Rockville Evangelical Mission Church, Preliminary Plan, 120130210

Staff Report Date: 06/26/15

Description

Figure 4 Landscape Plan

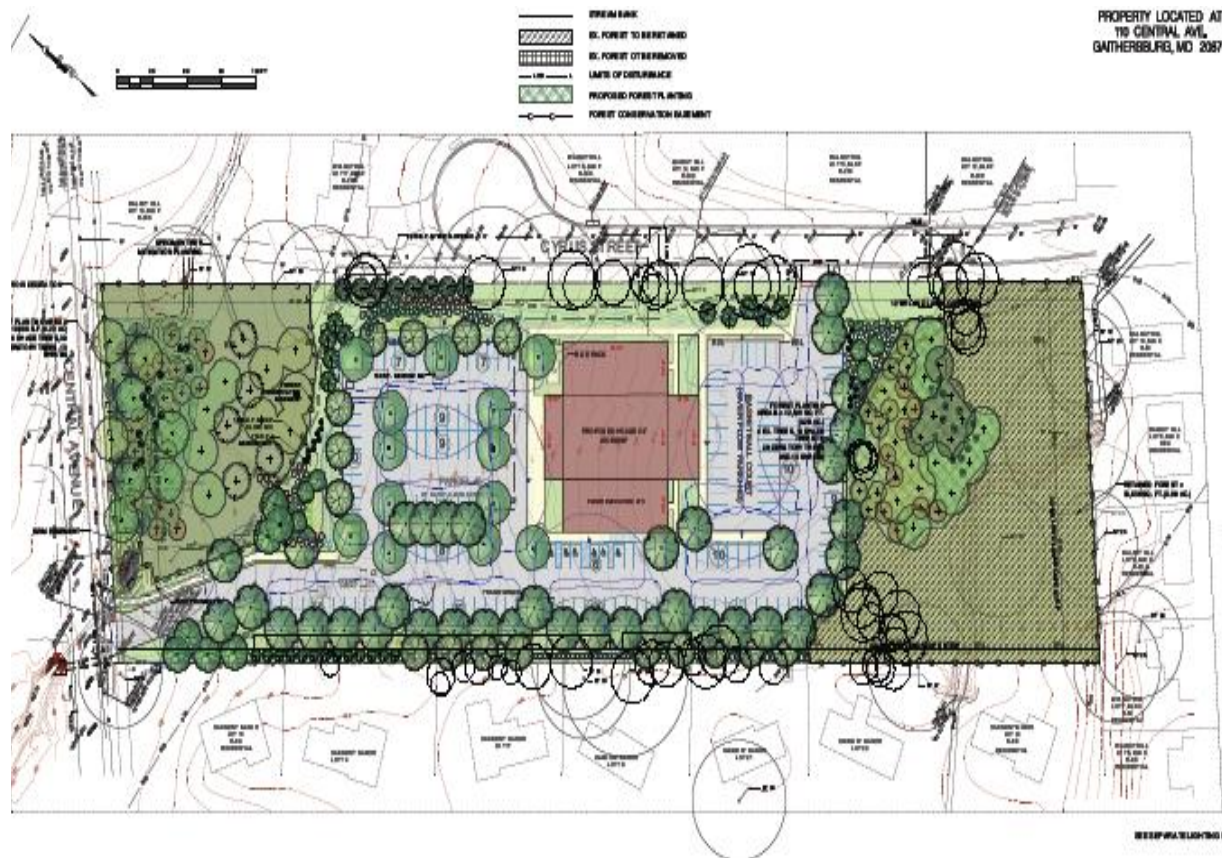
The Landscape Plan addresses required screening of adjacent uses and shows the required setbacks, including the 40-foot front yard building restriction line (BRL) along. The Lighting Plan includes general lighting on the parking lot and security lighting around the building.

13. Prior to Certified Preliminary Plan approval, the Applicant must submit a revised Landscape and Lighting Plan for inclusion of the plan set and in compliance with the Planning Board’s conditions of approval. Provide a note on the Lighting Plan to state: “The lighting distribution and photometric plan with tabulations must conform to IESNA standards for adjacent residential development.”

14. The Landscape Plan must include street lamps on Central Avenue, internal sidewalks, benches, trash receptacles, the trash dumpster and its enclosure, and bike racks. These elements must be installed prior to the issuance of the Use and Occupancy Certificate; street tree planting on Central Avenue may wait until the next growing season.
